REMARKS

IV. The Objections to the Drawings are Overcome

The elements of the claims depicted, for example, in FIGS. 11 and 13. For illustrative purposes, a marked-up copy of FIG. 11A is presented here:

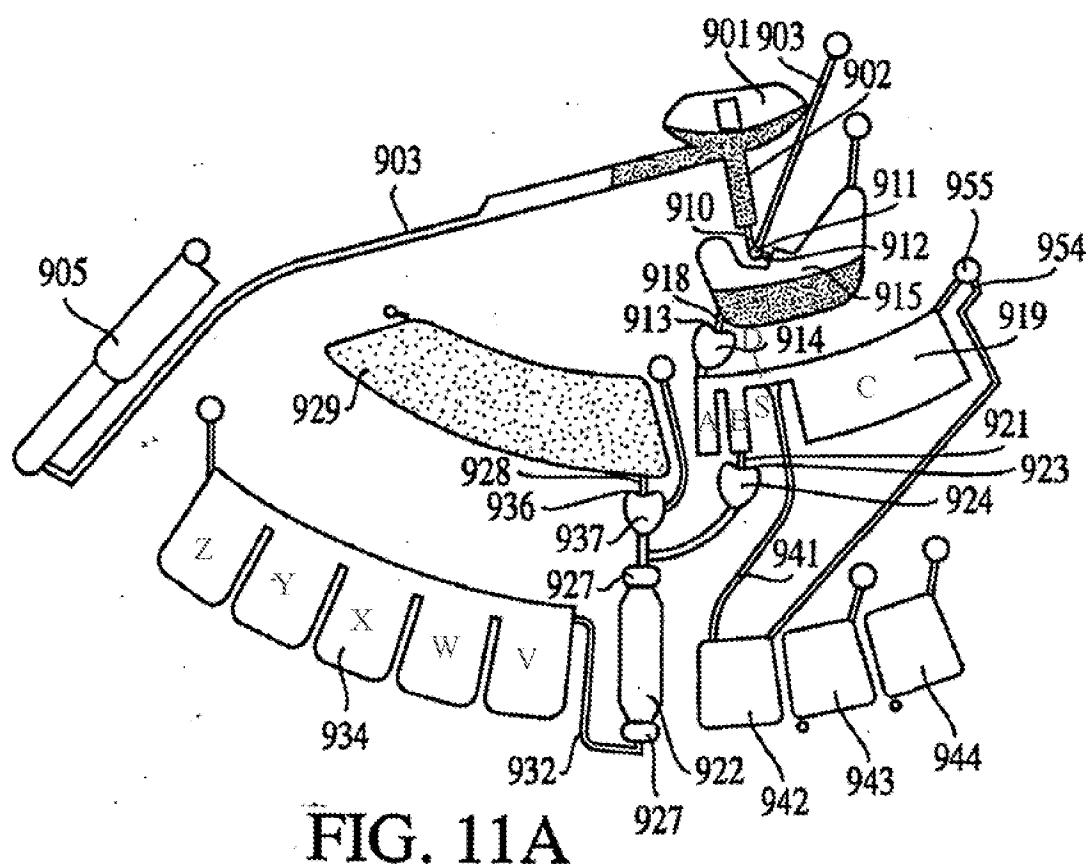
The drawings are objected to under 37 C.F.R. § 1.83(a) for allegedly not showing every feature of the invention specified in the claims. Applicants respectfully disagree and traverse the objection.

The microsystem platform of claim 9 is described, for example, in ¶ 0046 of the specification as published. The rotatable platform of claim 9, is illustrated, for example, in FIG. 13B in combination with ¶ 0046 and FIGS. 11A-11J. The entry port chamber is illustrated, for example, with reference character 901 and ¶ 0182 of the specification as published. The first microchannel is illustrated, for example, with reference character 910 and the mixing chamber is illustrated, for example, with reference character 915. The mixing chamber is illustrated, for

example, with reference character 915, the second microchannel is illustrated, for example, with reference character 918, the secondary metering chamber is illustrated, for example, with reference character 919.

A first overflow portion is depicted as [A], a first metering portion is depicted as [B], a second overflow portion is depicted as [C], the first metering portion is depicted as [B], a septum is depicted as [S] and a fluid connection is depicted as [D] in the marked up FIG. 11A shown above.

The third microchannel is illustrated, for example, with reference character 941, the read chamber is illustrated, for example, with reference character 942, the secondary metering chamber is illustrated, for example, with reference character 915, the fourth microchannel is illustrated, for example, with reference character 921, the analyte separation assay chamber is illustrated, for example, with reference character 922, the analyte separation chamber is illustrated, for example, with reference character 922, the fifth microchannel is illustrated, for example, with reference character 928, the separation matrix buffer reservoir is illustrated, for example, with reference character 929, the sixth microchannel is illustrated, for example, with reference character 932, the read window manifold is illustrated, for example, with reference character 934.

A series of chambers are depicted as [V,W,X,Y,Z] in the marked up FIG. 11A shown above.

The elements of the microsystem platform of claim 10 are also illustrated in the figures. The metering capillary is illustrated, for example, with reference character 902, the overflow capillary is illustrated, for example, with reference character 903, the mixing chamber is illustrated, for example, with reference character 915, the overflow chamber is illustrated, for example, with reference character 905, the entry port chamber is illustrated, for example, with reference character 901, the capillary junction is illustrated, for example, with reference character 912, the mixing chamber is illustrated, for example, with reference character 915, the entry port chamber is illustrated, for example, with reference character 901 and the assay chamber is illustrated, for example, with reference character 922.

The sacrificial valves of claims 11-13 are illustrated, for example, with reference characters 911, 921 and 936. The third, fourth, fifth or sixth microchannels of claim 11 are illustrated, for example, with reference characters 941, 921, 928 and 932, respectively.
